YUCCA MOUNTAIN - REQUEST FOR ADDITIONAL INFORMATION - SAFETY  
EVALUATION REPORT, VOLUME 3 - POSTCLOSURE CHAPTER 2.2.1.3.2,  
MECHANICAL DISRUPTION OF ENGINEERED BARRIERS, 3RD SET - (DEPARTMENT  
OF ENERGY'S SAFETY ANALYSIS REPORT SECTION 2.3.4)

**RAI Volume 3, Chapter 2.2.1.3.2, Third Set, Number 2:**

**RAI Volume 3, Chapter 2.2.1.3.2, Third Set, Number 3:**

**RAI Volume 3, Chapter 2.2.1.3.2, Third Set, Number 4:**

Figure 1. Contours of Reaction Forces (N) in a State during Quasi-Static Analysis for the Initial Thickness of the Drip Shield Components and Initial Average Rubble Load Distribution

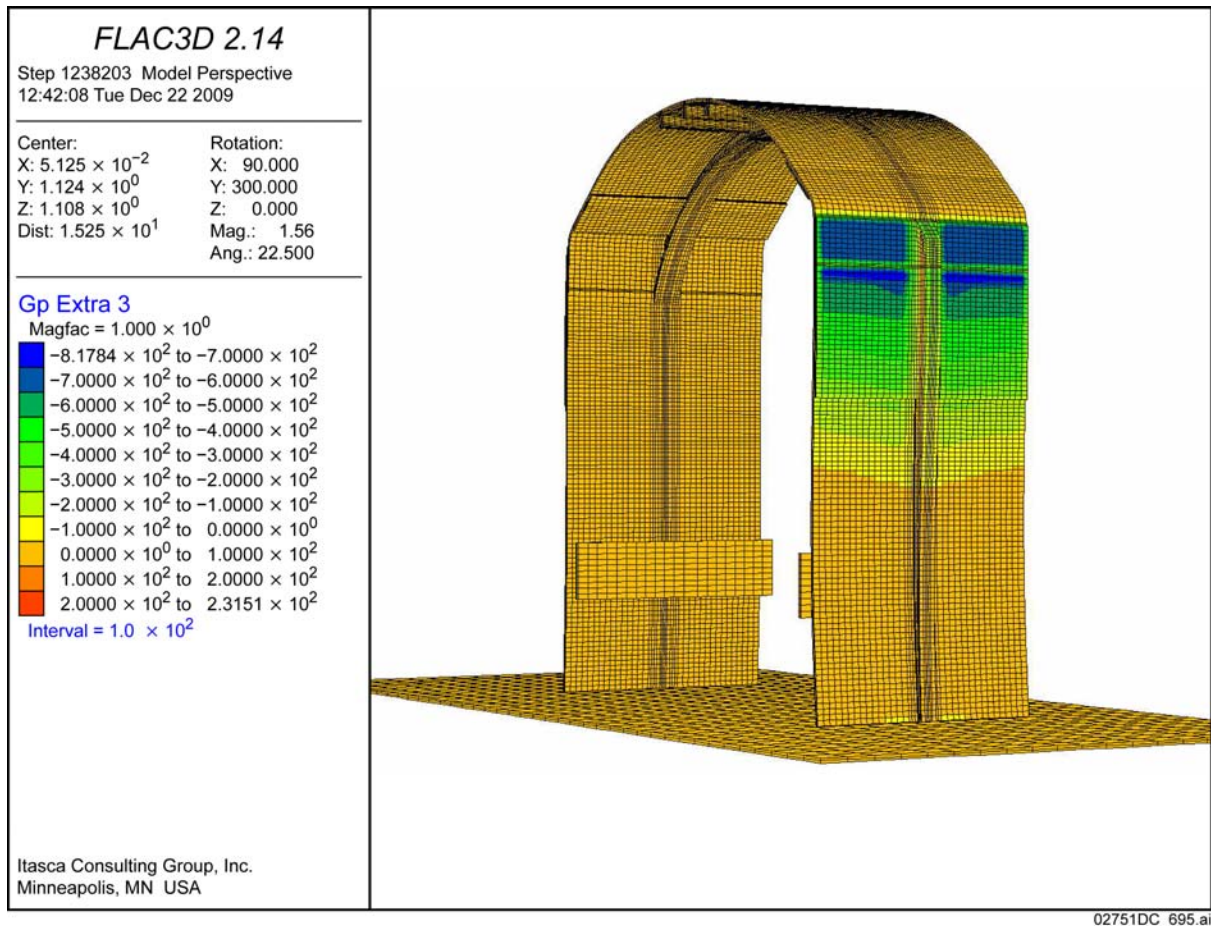
Demonstrate that the drip shield quasi-static limit load analyses appropriately represent the potential effects on drip shield performance from horizontal accelerations during vibratory ground motion from seismic events.

**Basis:** To obtain an approximation of the peak ground acceleration that the drip shield can withstand, the applicant monotonically increased the initial static vertical load, while keeping constant the lateral rubble loading (SNL, 2007ap; Section 6.4.3.2.2.2). The approach appears to be inconsistent with the dynamic loading being represented in the quasi-static analysis, given that dynamic amplifications in the horizontal accelerations are expected to be similar to those in the vertical direction, according to applicant's results (BSC, 2004al; Appendix P).

The lateral loads changed as a result of the interaction between the drip shield legs and surrounding rubble. The rubble–sidewall interaction is represented by elastic springs whose stiffness is equivalent to the stiffness of the rubble accumulated between the drip shield legs and the drift walls. Figure 1 shows the typical contours of the reaction forces due to interaction between the drip shield and rubble for the case of the initial drip shield configuration and the average initial rubble pressure distribution (SNL 2007, Table 6-136). The rubble reaction forces can only be compressive (otherwise a gap is created), acting to compress the drip shield legs. In this particular case, the lower portion of the drip shield legs are moving inward (thus, no reaction forces there), while the upper portion, at the shoulders and below, is moving outward, resulting in rubble backpressure. The contours are shown for the quasi-static state in which the vertical load is magnified by a factor of 13.2 and the average vertical pressure is then calculated as  $13.2 \times 127.86 \text{ kPa} = 1,688 \text{ kPa}$ . (The initial average vertical rubble pressure on the drip shield crown, before amplification, is 127.86 kPa (SNL 2007, Table 6-136)). The maximum lateral load for this state can be calculated based on Figure 1. The maximum horizontal force is 818 N.

Considering the approximate zone edge length of the numerical grid is 0.03 m, the maximum lateral pressure is approximately:

$$p_{\max} = \frac{818 \text{ N}}{0.03^2 \text{ m}^2} = 909 \text{ kPa} \quad (\text{Eq. 1})$$

This value can be compared to the average initial pressure on the left and right sides of the drip shield, 41.99 and 61.87 kPa, respectively (SNL 2007, Table 6-136). Thus, the lateral rubble load changes substantially during quasi-static analysis of the drip shield, and is about  $(909 \text{ kPa}/1,688 \text{ kPa}) = 54\%$  of the vertical load for this state. The difference between the vertical and lateral loads is that the vertical load is an active load due to dynamic amplification of the rubble weight, while the lateral rubble load, as indicated by the contours of reaction forces shown in Figure 1, is a passive load due to pressure of the rubble against the deforming drip shield (as explained in detail in SNL 2007, Section 6.4.3.2.2.3).

Figure 1. Maximum Effective Plastic Strain in the Drip Shield Framework as a Function of Load for Rubble Load Realization 3

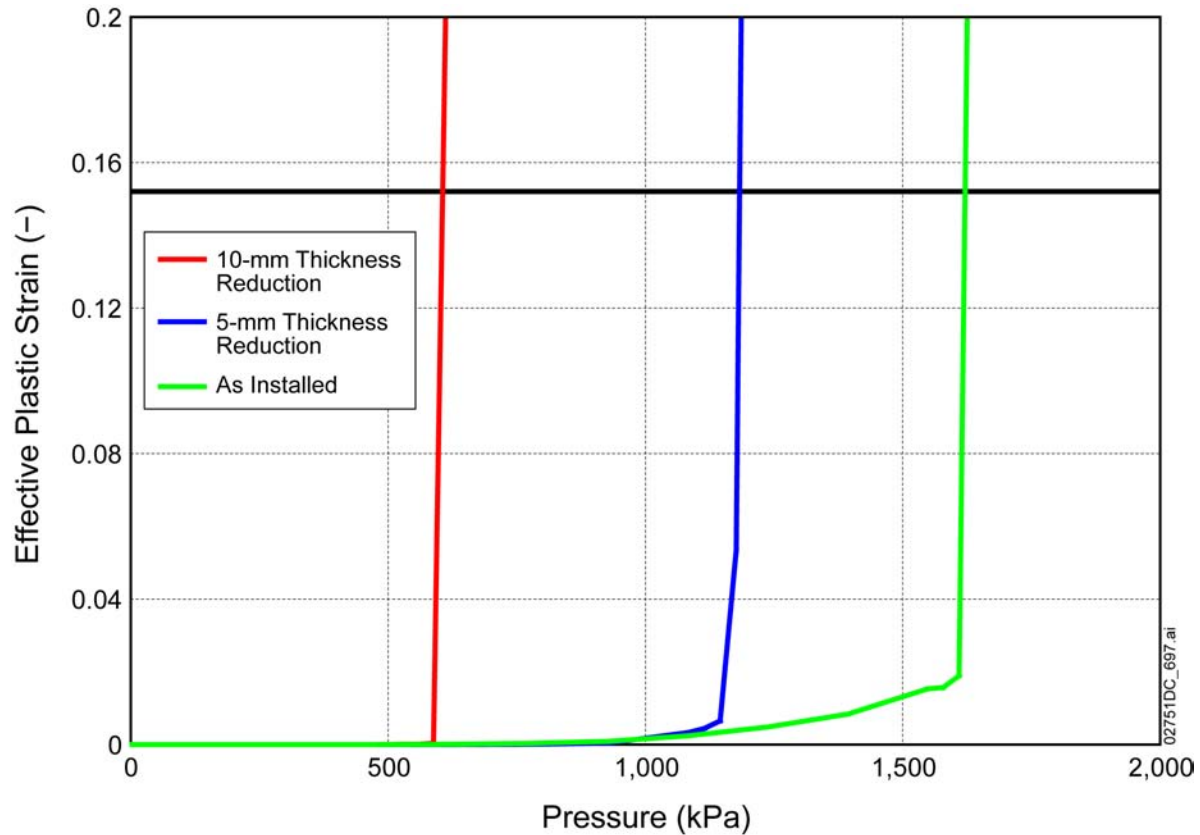
For the drip shield two-dimensional model subjected to acceleration time histories, demonstrate that a failure criterion based on the effective plastic strain at the end of the dynamic simulations is appropriate. In addition, demonstrate that the effective plastic strain from one event is considered in the analyses of subsequent events.

**Basis:** DOE uses the maximum effective plastic strains at the end of the time history analyses to evaluate the drip shield performance (SAR Section 2.3.4.5.3.3.3 and SAR Figure 2.3.4-85) but does not provide maximum effective strain-time and maximum effective plastic strain-time relationships.

DOE has not shown that the maximum effective plastic strains at the end of the simulation, as calculated in UDEC, appropriately represents the maximum effective plastic strains experienced by components subjected to cyclic loading, such that the tensile effective strain-failure criterion (SAR Section 2.3.4.5.1.2.2) is not underestimated.

Figure 1 illustrates the process of the buckling of the sidewalls for rubble load realization 3, based on the three-dimensional, quasi-static calculations. Load realization 3 was selected for the analysis because that realization results in the largest vertical load on the drip shield crown (SNL 2007a, Section 6.4.3.2.2.2 and Table 6-136). For a given thickness of the drip shield framework, effective plastic strain increases very slowly until a critical pressure is reached, at which point the sidewalls become unstable and the effective plastic strain increases abruptly by an order of magnitude or more. This abrupt strain increase is attributed to buckling. Note also that the effective plastic strain when the sidewall buckles is small relative to the ultimate tensile strain for Titanium Grade 24 (SNL 2007a, Table 6-134), which is shown as a solid black horizontal line near the top of Figure 1. (Titanium Grade 24 was used in the calculations as a proxy for Titanium Grade 29, which is the material for the drip shield framework in the current design (SNL 2007a, Section 4.1.5)).

The legend for Figure 1 presents the thickness reduction for the drip shield components. The thickness reductions of 0 mm (as-installed), 5 mm, and 10 mm represent the effect of general corrosion over long periods of time. These three states correspond to plate thicknesses of 15 mm (as-installed), 10 mm, and 5 mm, respectively. These thickness reductions therefore span a range of states, from the as-installed condition to a condition that is close to failure.

Table 1 presents the numerical data points that define each of the curves shown in Figure 1. Each curve includes a bend or “knee.” The “knee” represents the computational point with the greatest pressure before the sidewalls become unstable and the effective plastic strain increases

by approximately an order of magnitude (or more) for the next pressure increment in the quasi-static calculation. Inspection of Figure 1 confirms that the maximum effective plastic strain at the “knee” of each curve is quite small relative to 0.152, the ultimate plastic strain of Titanium Grade 24 (SNL 2007a Table 6-134). In other words, the effective plastic strain remains small until the pressure exceeds the critical pressure for buckling.

Figure 1. Geometrical Representation Used in the Analysis of the Mechanical Interaction between the Drip Shield and the Rubble during Seismic Ground Motions Shown on the Drip Shield Scale

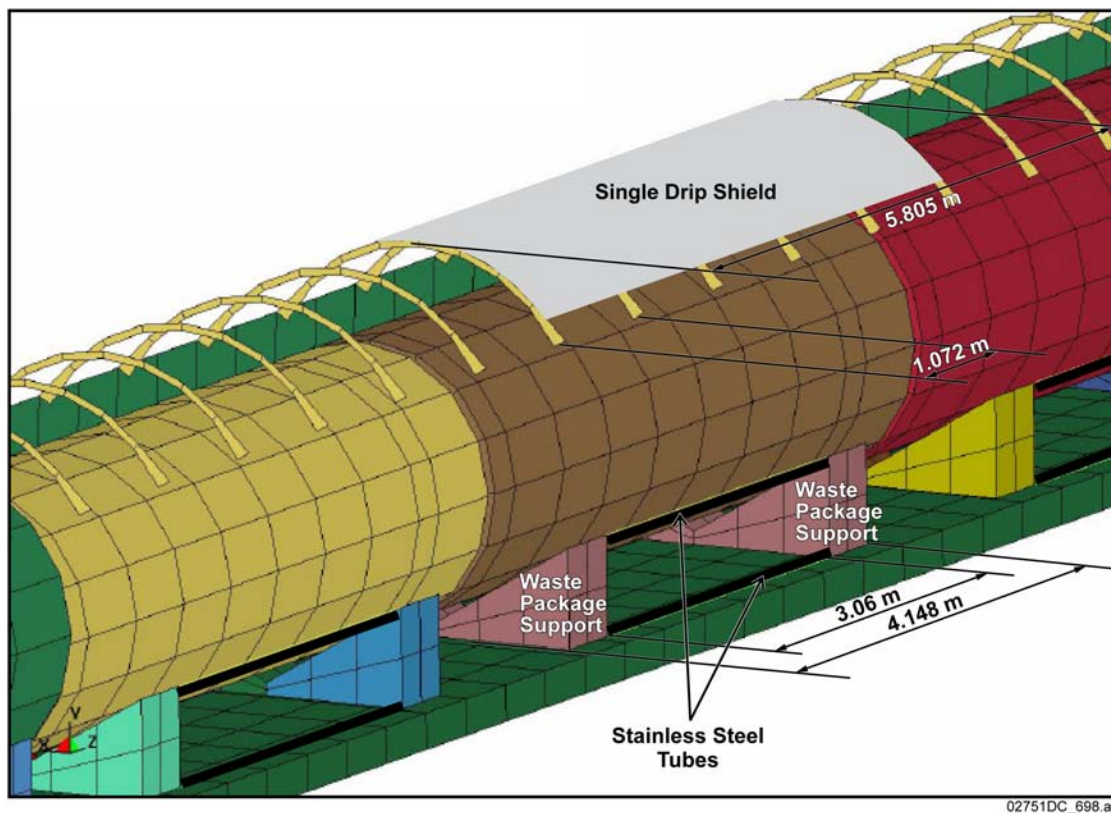
Demonstrate that including the base of the emplacement pallet in the dynamic analyses of drip shield mechanical performance does not overestimate drip shield capacity during vibratory ground motions.

**Basis:** DOE dynamic analyses in SAR section 2.3.4.5.3.3 include the waste package base pallet in the two dimensional model (e.g., SAR Figure 2.3.4-84). Some of the results of these analyses show that deformation of the drip shield sidewall may be influenced by the presence of the base pallet (e.g., SAR Figure 2.3.4-85). However, the base pallet only extends across approximately one fifth of the drip shield length. DOE analyses have not discussed the potential effects of drip shield-base pallet interactions during dynamic analyses, and have not included analyses in which the drip shield framework performance is not be influenced by the base pallet.

As illustrated in Figure 1, the emplacement pallet is included in the dynamic analysis of drip shield mechanical performance (SNL 2007a, Section 6.4.4). In this two-dimensional representation, the emplacement pallet extends along the entire length of the drip shield. Figure 2 illustrates the actual, three-dimensional geometry of the standard emplacement pallet, the drip shield, and the waste package. The standard emplacement pallet, which accounts for approximately 90% of the pallets in the repository, consists of two waste package supports (sometimes called cradles or pallet bases) connected by four stainless steel tubes (two on each side of the pallet) as shown in Figure 3. Although the two waste package supports included in one pallet extend along approximately 20% of the shield length (i.e., length of one waste package support is 0.5429 m compared to 5.805 m drip shield length), the entire standard emplacement pallet (4.148 m long) extends along 71% of the total drip shield length.

The interaction between the drip shield and the pallet during strong seismic ground motions is complex. Initially, as shown in Figure 1, the drip shield and the pallet are not in contact. During the early portion of strong ground motions affecting this mechanical system, the drip shield and the pallet will move relative to each other, occasionally physically impacting each other. The impact forces may cause localized damage to the drip shield. Thus, as long as the pallet is free to move inside the drip shield, its presence in the model as an object that can physically impact the drip shield results in an overestimate of damage of the drip shield. The potential beneficial effect of the pallet on the drip shield damage and stability is when the plastic deformation of the drip shield legs is sufficient to allow them to continuously contact the pallet, which then acts as a strut preventing further inward deformation of the drip shield legs. As the strong ground motions continue to cause dynamic lateral loads on the drip shield sides via the rubble, forces between the drip shield and the pallet will typically increase with accumulation of inward plastic deformation. Continued inward deformation of the legs as the strong ground motions continue is a consequence of the fact that: (1) the plastic deformation accumulates with time, and (2) there is no mechanism for reversing the sense of plastic deformation, that is, generally closing the legs due to lateral rubble pressure. As shown in *Mechanical Assessment of Degraded Waste Packages and Drip Shields Subject to Vibratory Ground Motion* (SNL 2007a, Figures 6-60 to
